REMARKS

APPENDIX

VERSION WITH MARKINGS TO SHOW CHANGES MADE

Figure 1A

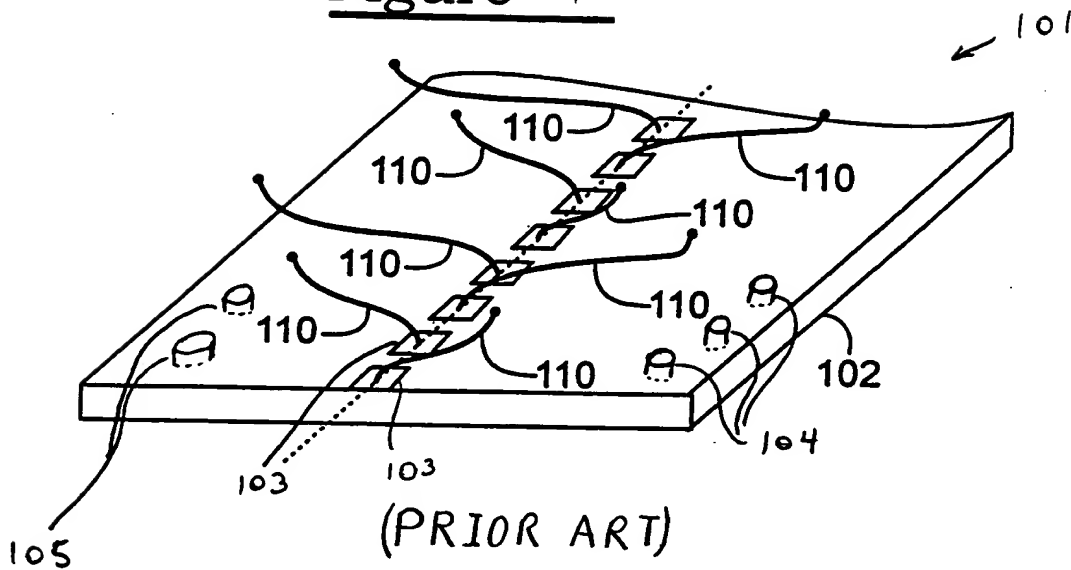
OK
SN
6/8/01

Additionally in the Office Action, the drawings were objected to for failing to show every feature of the invention as specified in the claims. Applicants respectfully submit that the drawings include all features recited in new claims 43-57. Further, as instructed by the Examiner, Figures 1A and 1B have been corrected in an accompanying Drawing Change Authorization Request (filed herewith) to include legends indicating that those drawings show prior art subject matter. In addition, Figures 2A-2D, 4, 6A, 6B, 6D-6G, 6I-6K, 7A, and 8A have been corrected in an accompanying Drawing Change Authorization Request to show cross-hatching of layers in respective sectional views. Figures 3D and 6C have been replaced with new Figures 3D and 6C by the Drawing Change Authorization Request. Applicants note that the Office Action objects to Figures 9A-9D based on the "insulative" and "conductive" layers not being cross-hatched. Applicants respectfully submit that Figures 9A-9D represent an alternative process for forming the resilient contact element of the present invention by showing a mold (901) and a deformable material (903) deposited on a substrate (905). All features in Figures 9A-9D are shown in section and are cross-hatched accordingly. Applicants respectfully submit that the drawings and specification are in good form for allowance.

Figure 1B

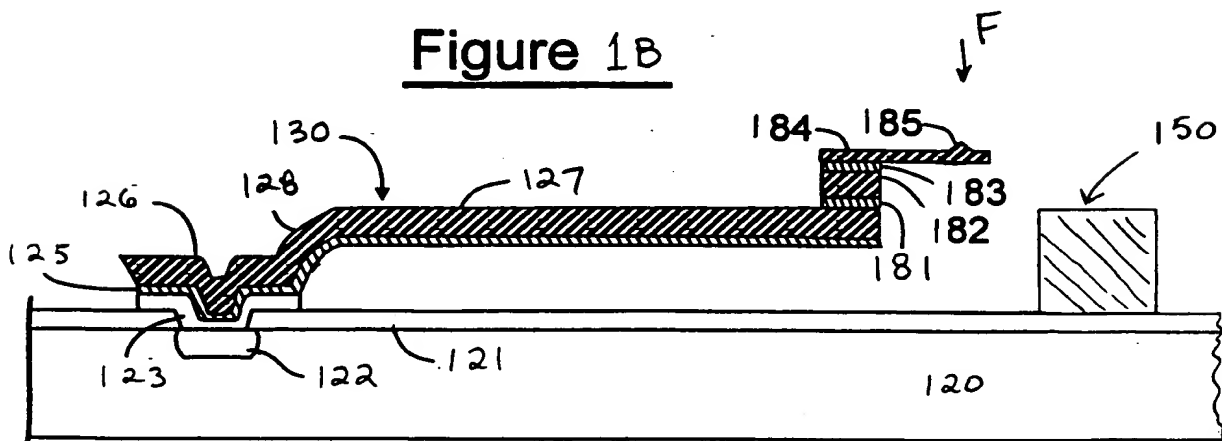
OK
SN
6/8/01

Fig. 2C

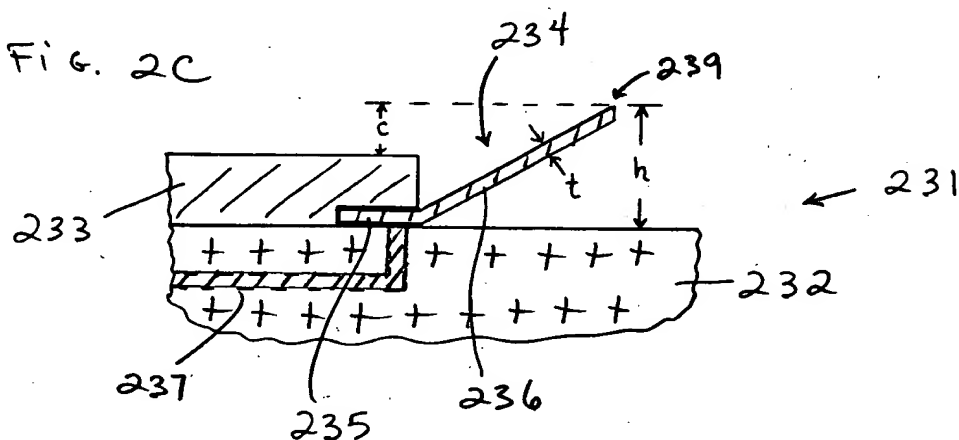
NOT OK (ALL)
SN
6/8/01

FIG. 2D

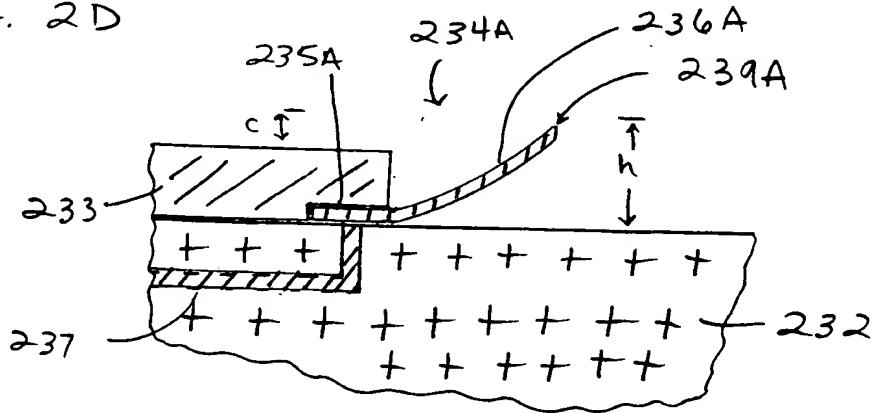
NOT OK
6/8/01
SN

FIG. 4

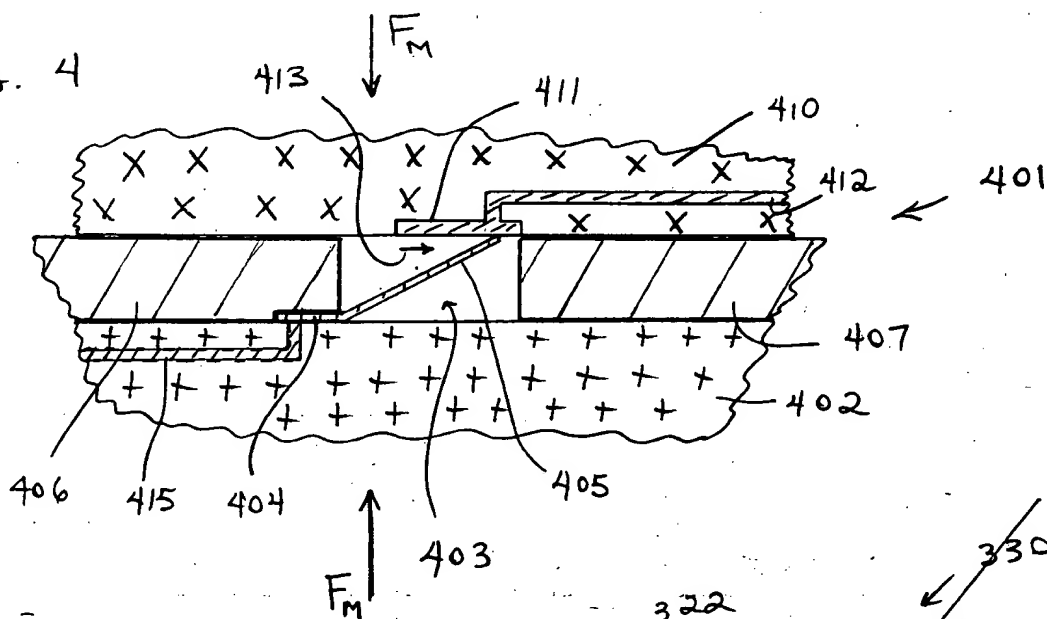
NOT OK
6/8/01
SM

FIG. 6D

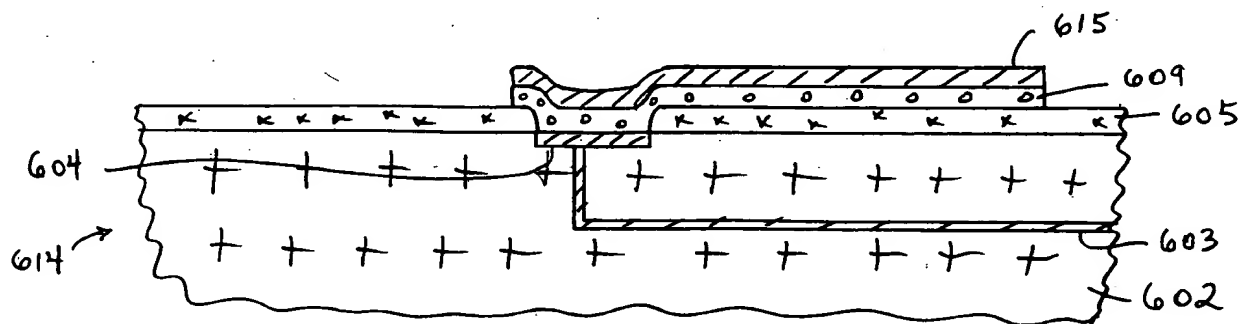
NOT OK (ALL)
6/6/01
SW

NOT OK (ALL)
6/8/01
SN

FIG. 6K

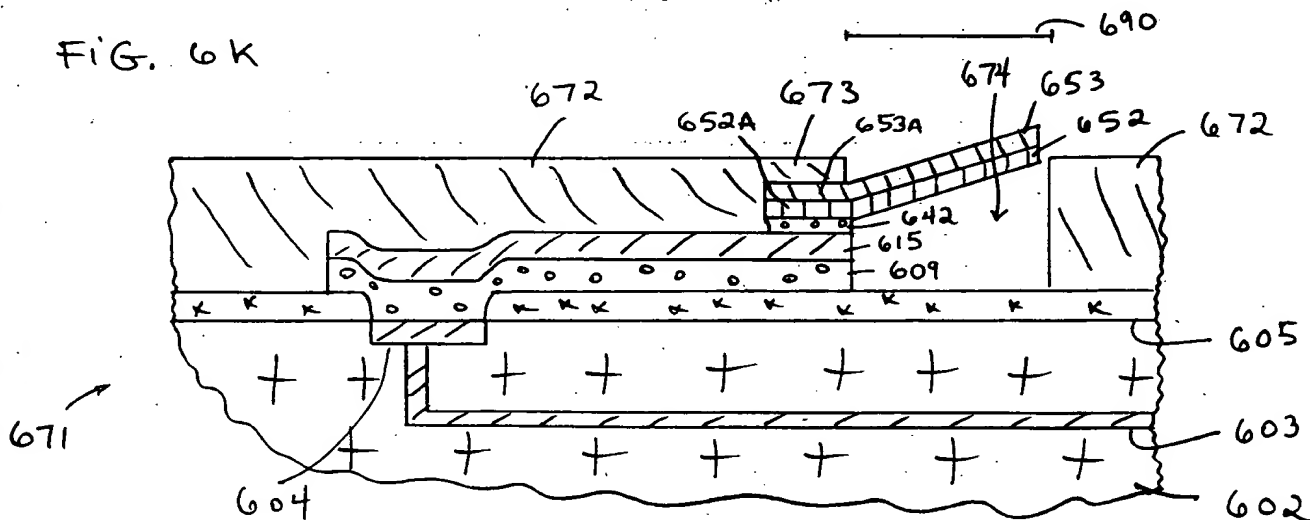
NOT OK (ALL)
6/8/01
SN

FIG. 7B

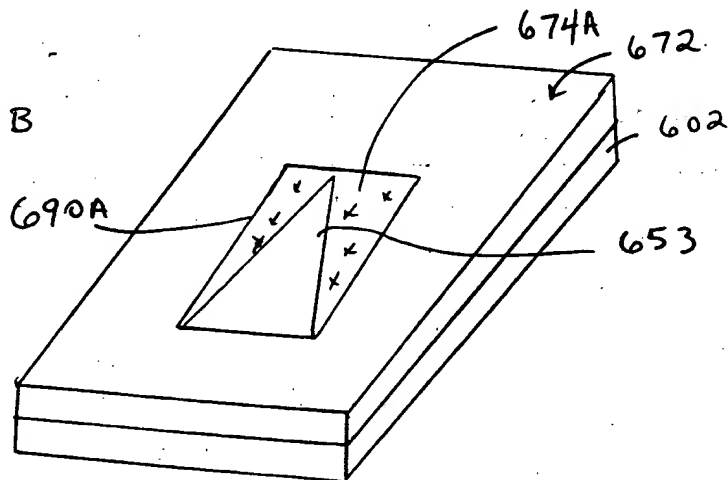
NOT OK
6/8/01
SN

NOT OK
6/8/01
SN

Fig. 3D

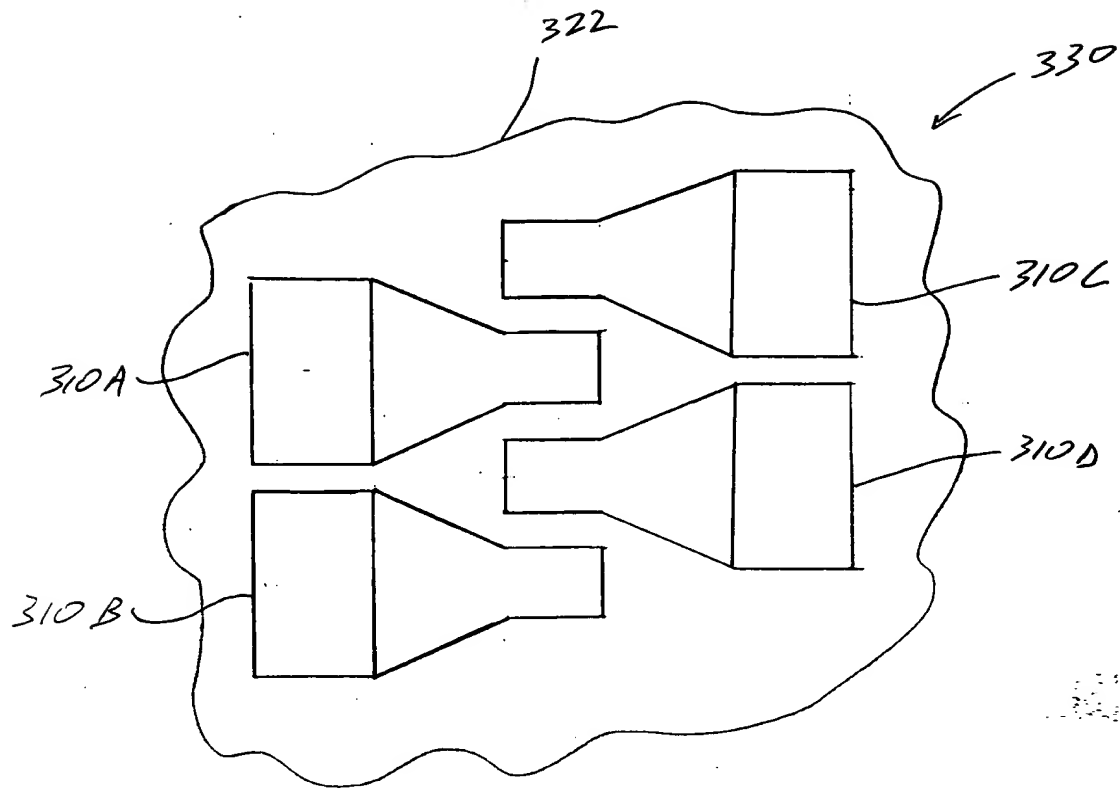
OK
6/8/01
SN

Fig. 6C

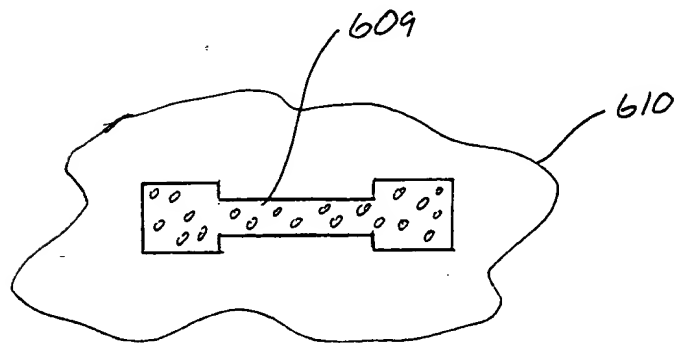
OK
6/8/01
SN
